CORRESPONDENCE/MEMORANDUM
DISTRICT #6

Date: July 16, 1998
To: File
From: Randy W. Luedtke, P.E.
District #6 Pavement Design Engineer
Subject: **PAVEMENT DESIGN REPORT**
Approval Letter

Project I.D. 8600-02-01
Chippewa Falls - Cornell Road
Jim Falls - CTH R
STH 178
Chippewa County

Subject: Pavement Documentation -**REVISED**
Project ID 8600-02-01
Chippewa Falls - Cornell
Jim Falls - CTH R
STH 178
Chippewa County

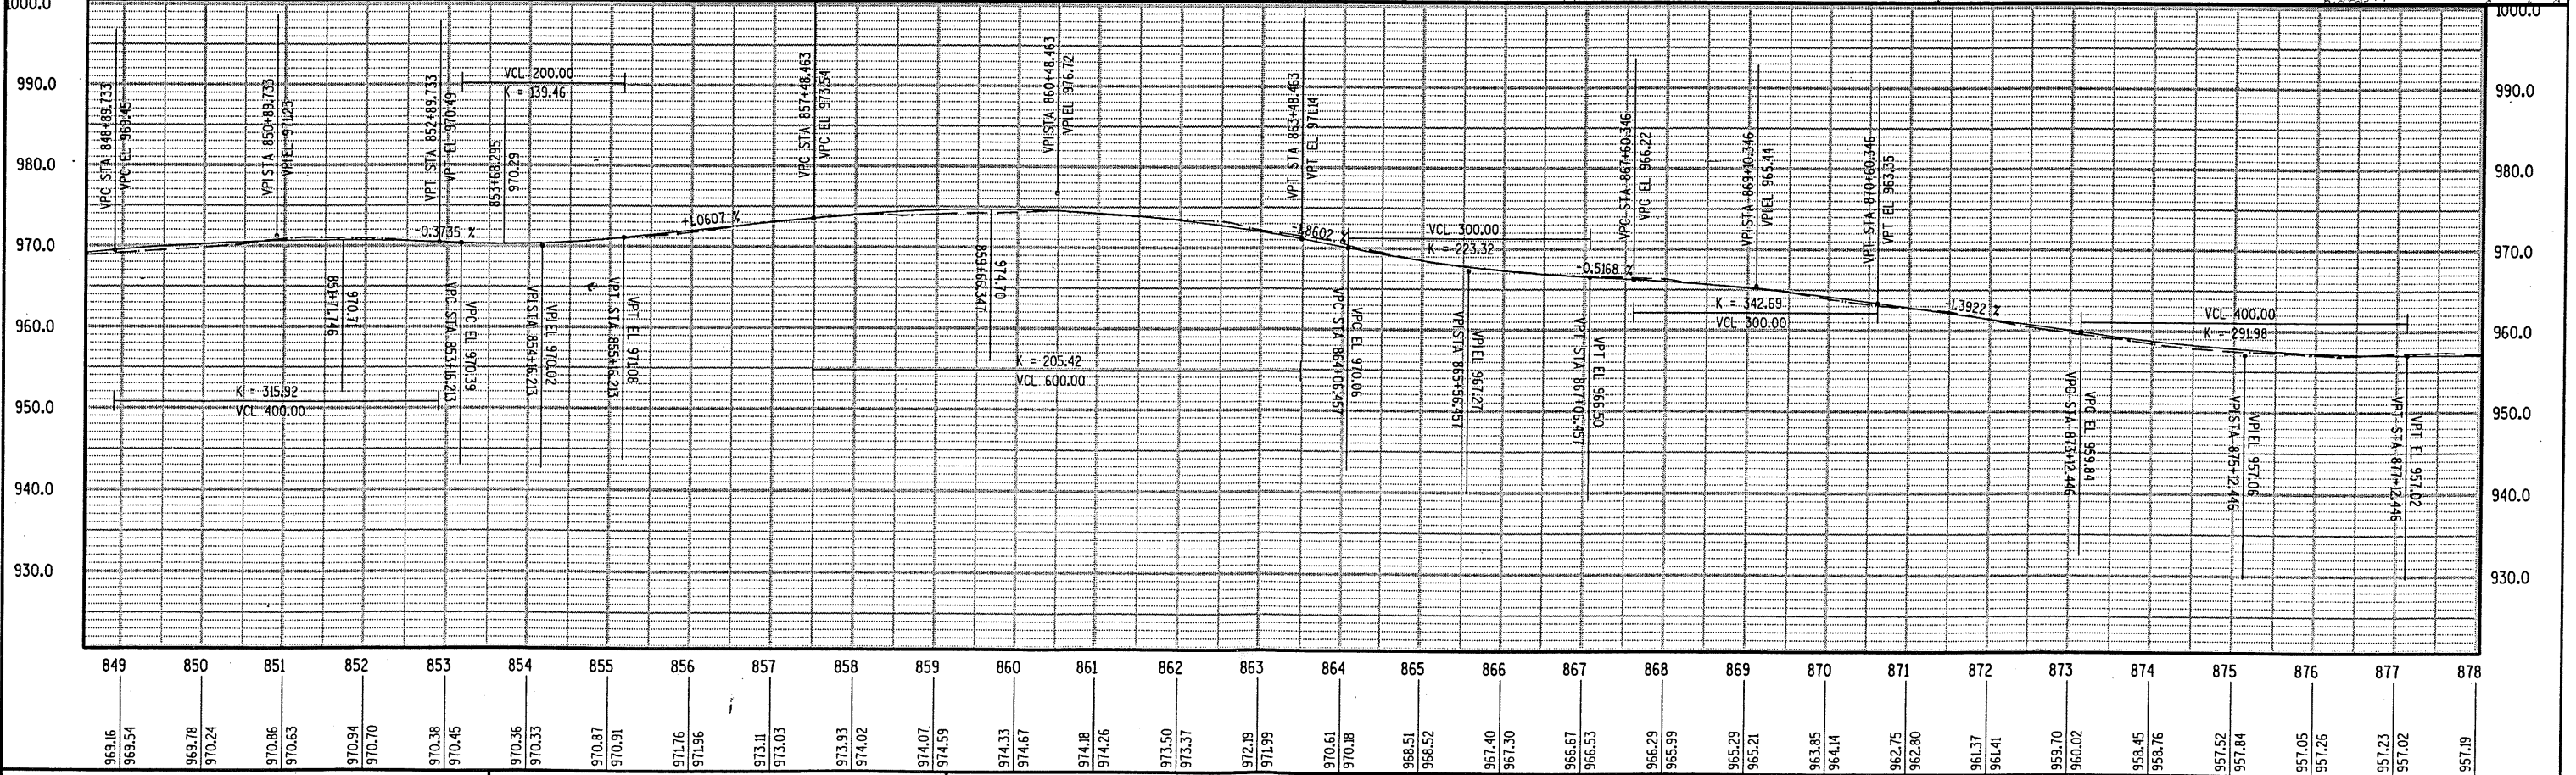
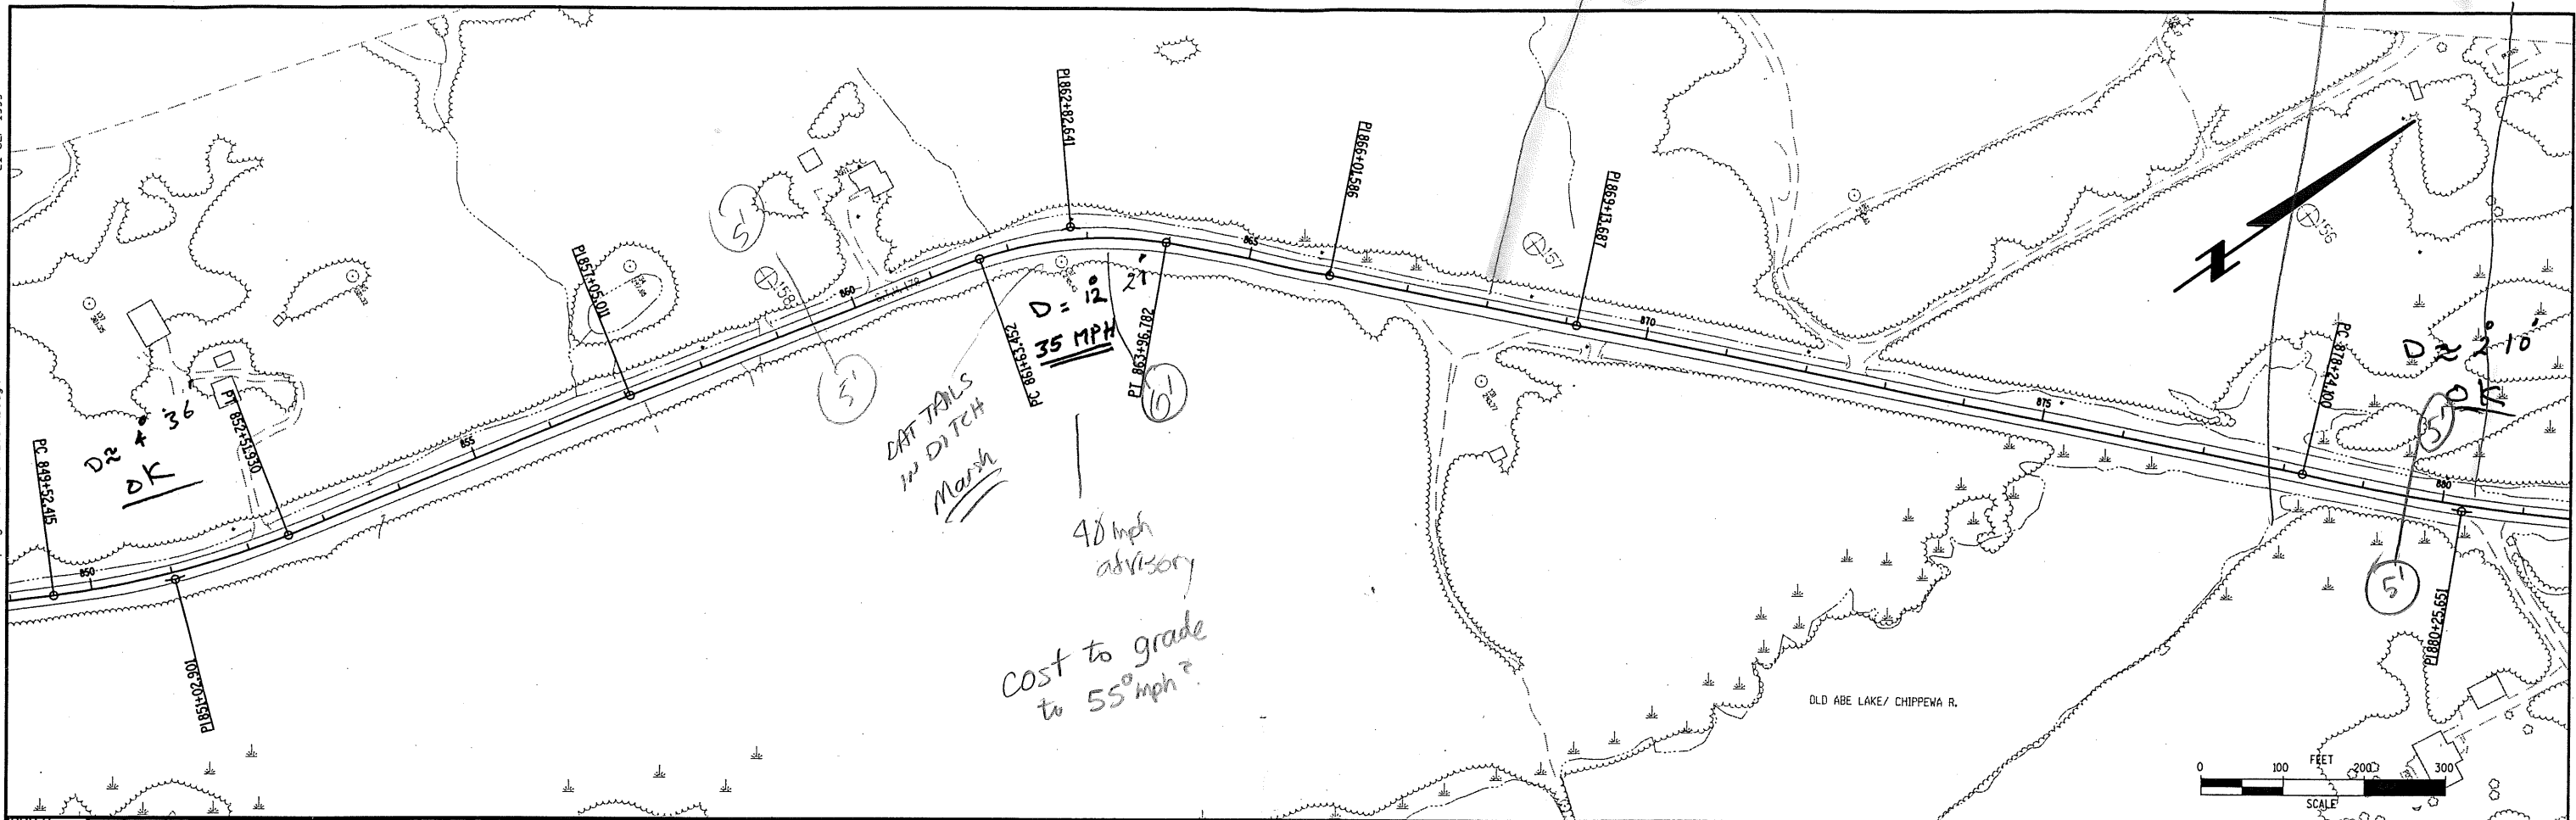
GRID 0 6' SHRS 12/13/99
some failure
GRID

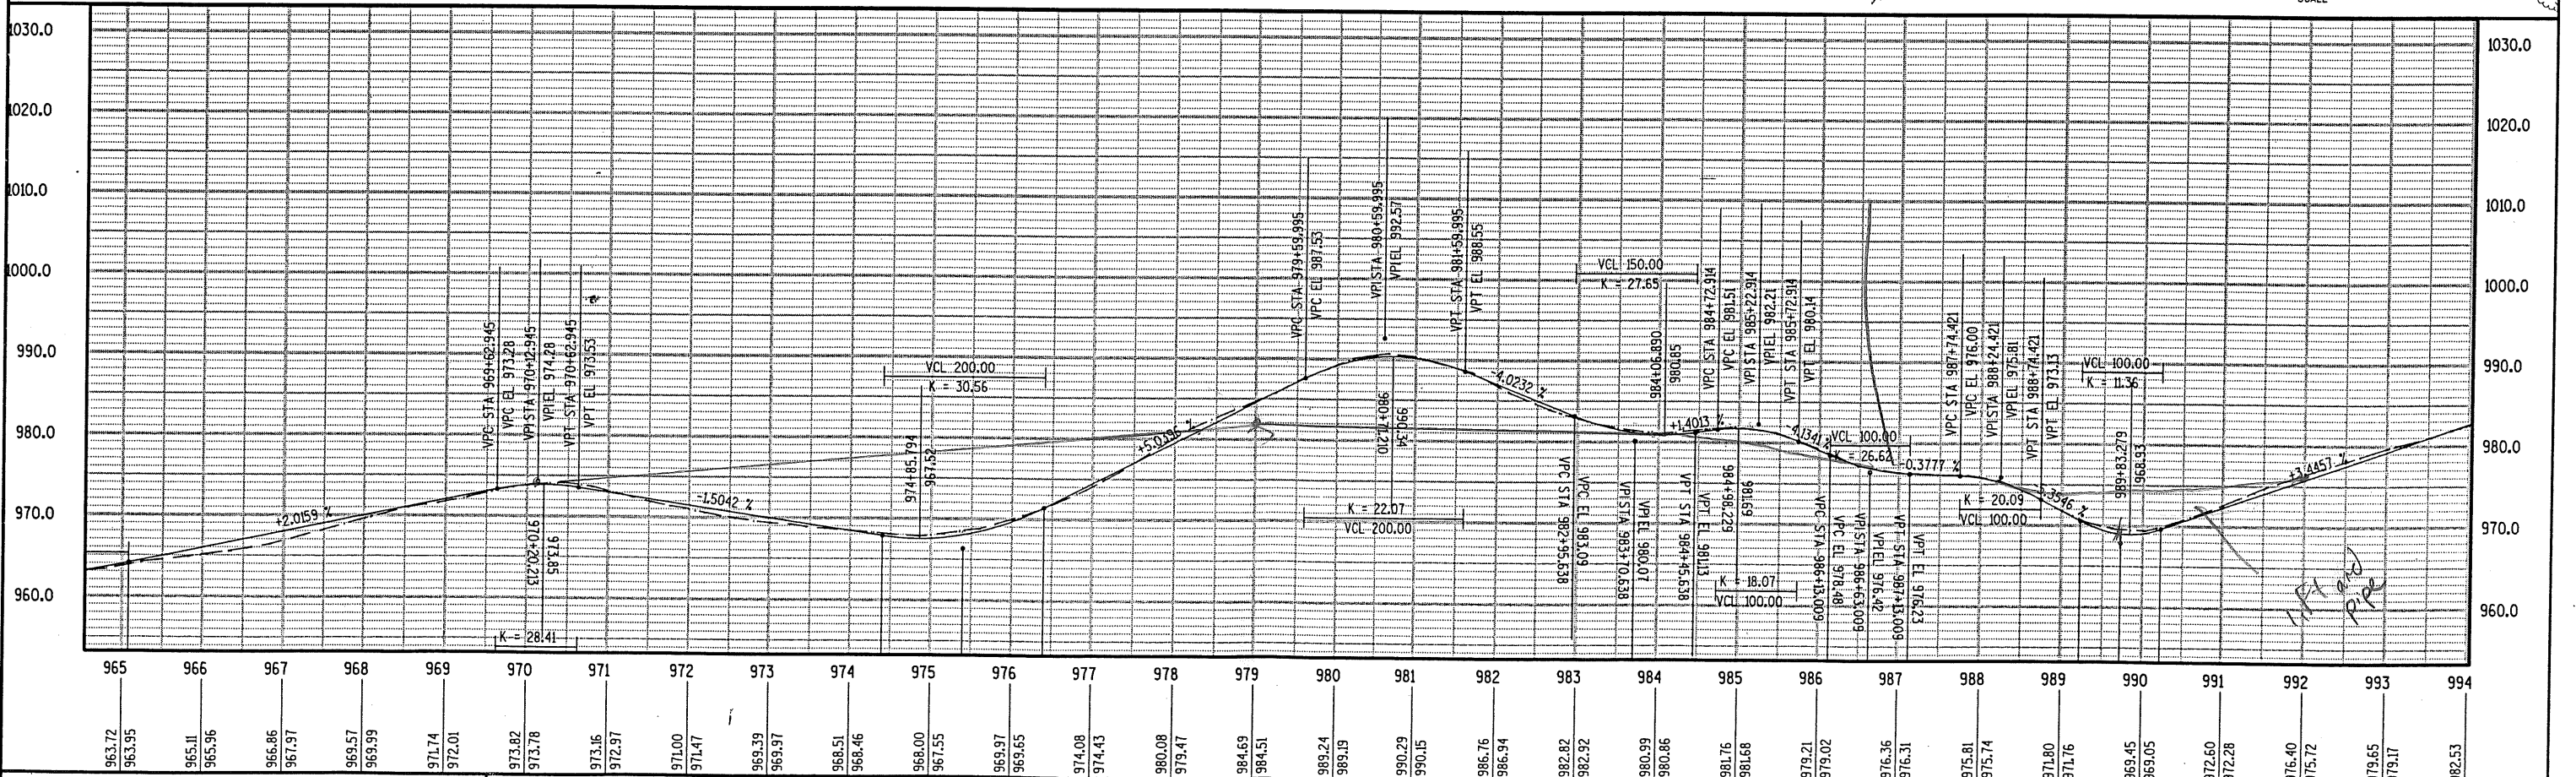
GRID WASH
PIPES
REPAIRED 12/15

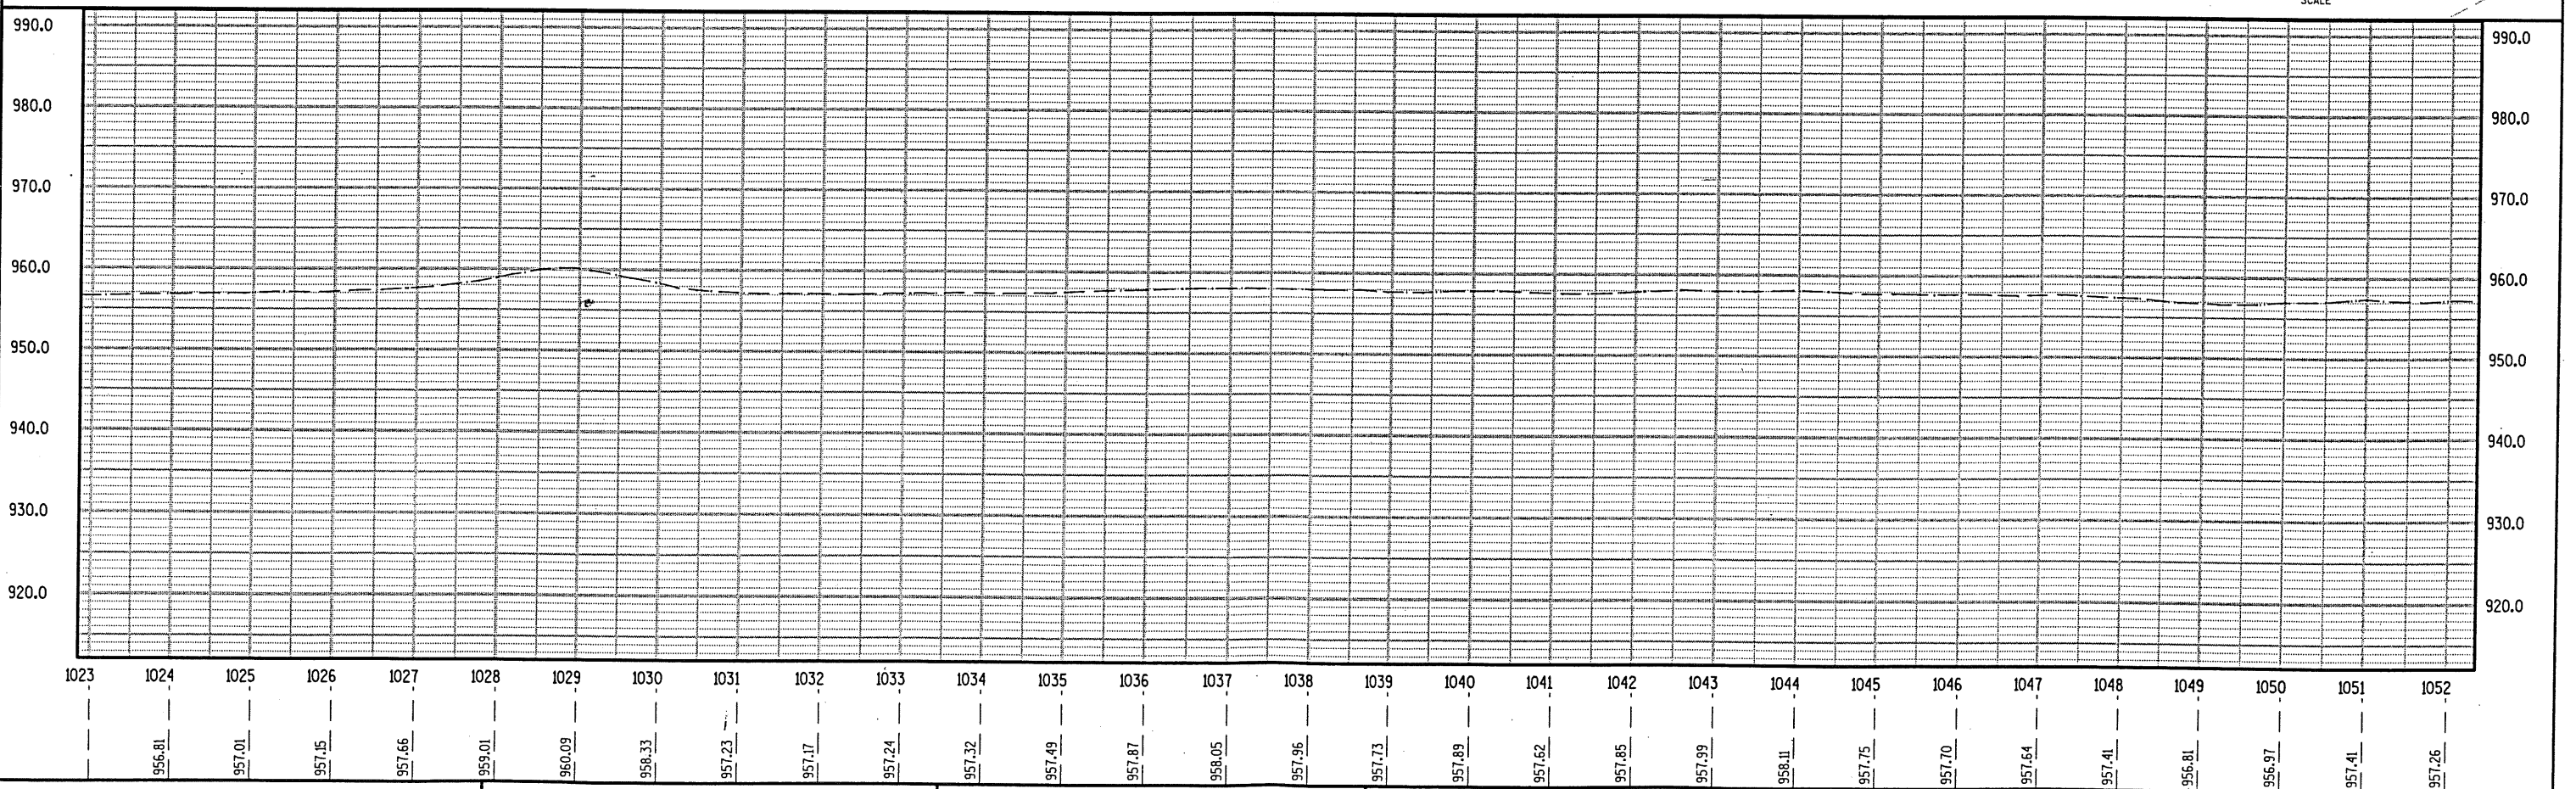
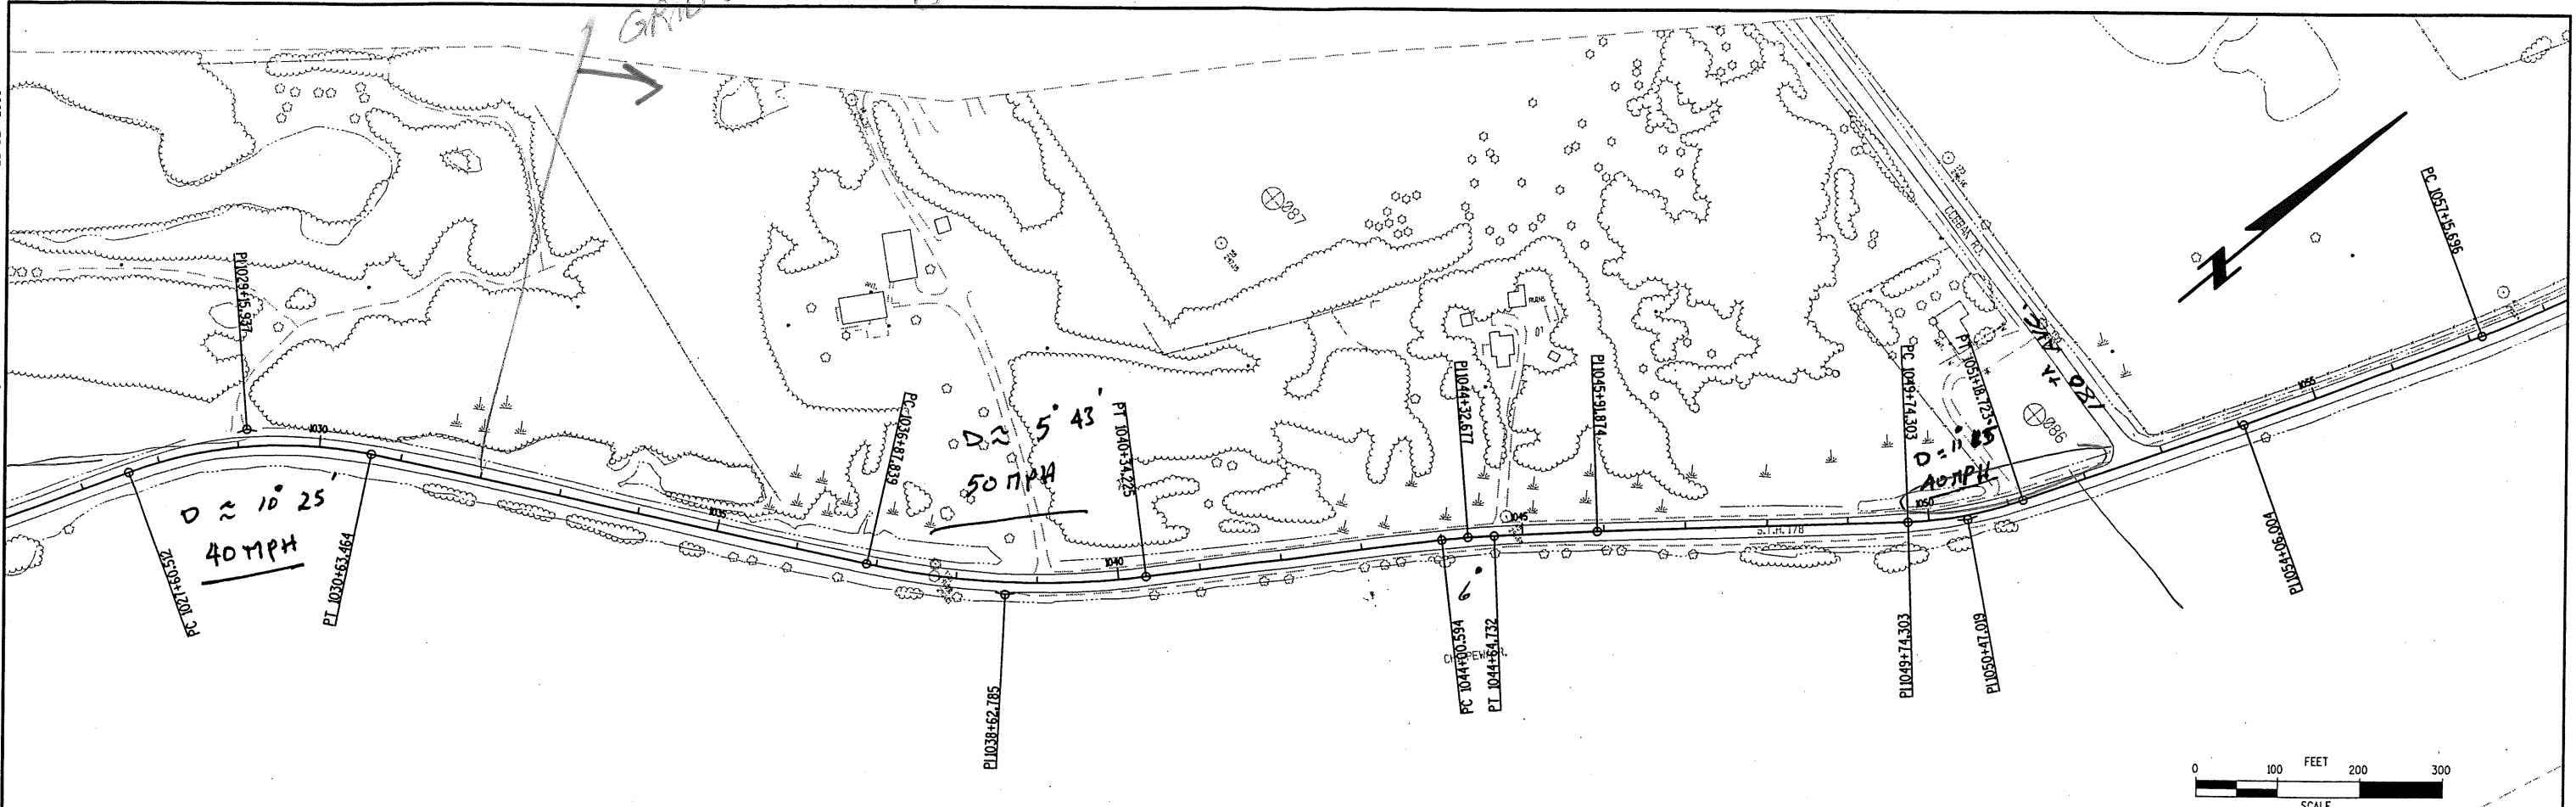
GRID ^W west side only → 12/15/
